Our Ref: 25215-L01-Information Request Response Letter

RE: INFORMATION REQUEST
A006982385
15 VILLA ST, ANNERLEY QLD 4103

This letter intends to address the information request regarding the Development Application submission for 15 Villa St, Annerley QLD 4103 issued by Brisbane City Council with reference A006982385 dated 15th April 2026.

Please refer to the Pre-developed and Post-developed Catchment layout plans (P400-A and P401-A) included in Appendix A of the updated Stormwater Management Plan for more details (document reference 25401-ENG-D).

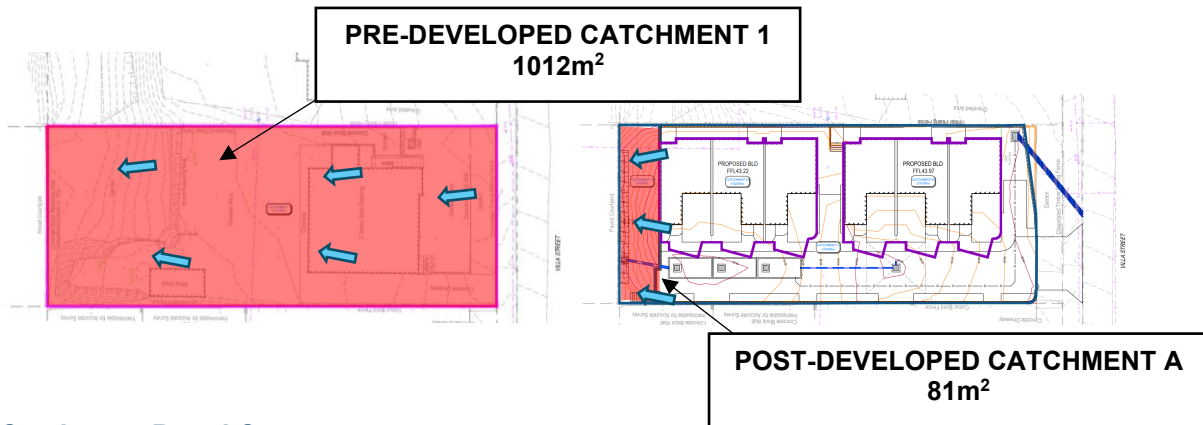
c) Provide a catchment plan of the existing and proposed catchment areas as a part of the engineering report and stormwater management plan.

Refer to Appendix A, P401- A for the post-development catchment layout plan.

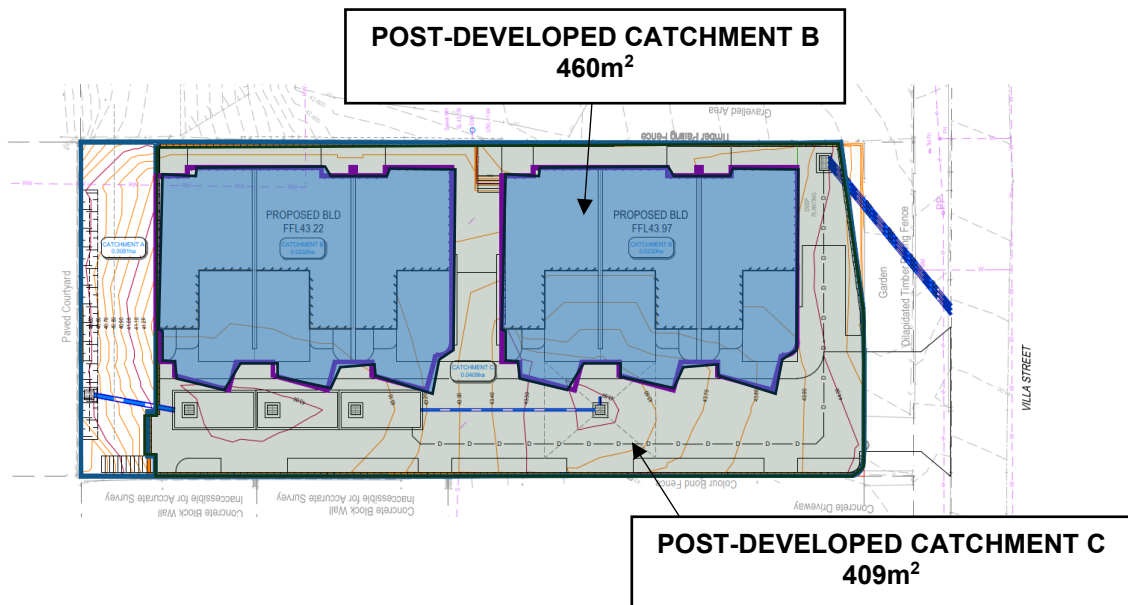
d) The catchment area developed coefficient of runoff has been indicated as 0.77 while the undeveloped coefficient of runoff is shown as 0.90. Please review and amend all the runoff coefficients as required in the engineering report and stormwater management plan.

Please refer to Section 5 of the updated Stormwater Management Plan for more details (document reference 25401-ENG-D). Due to the topography and existing records on site, it is proposed that stormwater runoff from the proposed development will be directed towards two lawful points of discharge.

The proposed deep planting area at the rear of the site will be discharged in a similar manner as the existing stormwater flows - towards the rear as a sheet flow less than pre-developed flows to ensure no worsening is caused at the rear proper.

The proposed roof, pavement, and landscape areas (excluding the deep planting rear of the site) from the development will be discharged towards a detention tank that will mitigate flows prior discharge. These developed flows are proposed to be pump out from the detention tank and discharge towards Villa Street via kerb and channel at less than 30L/s. The proposed pump design solution is in accordance with Brisbane City Council Planning Scheme Section 7.6.6.2 Pump and storage design.
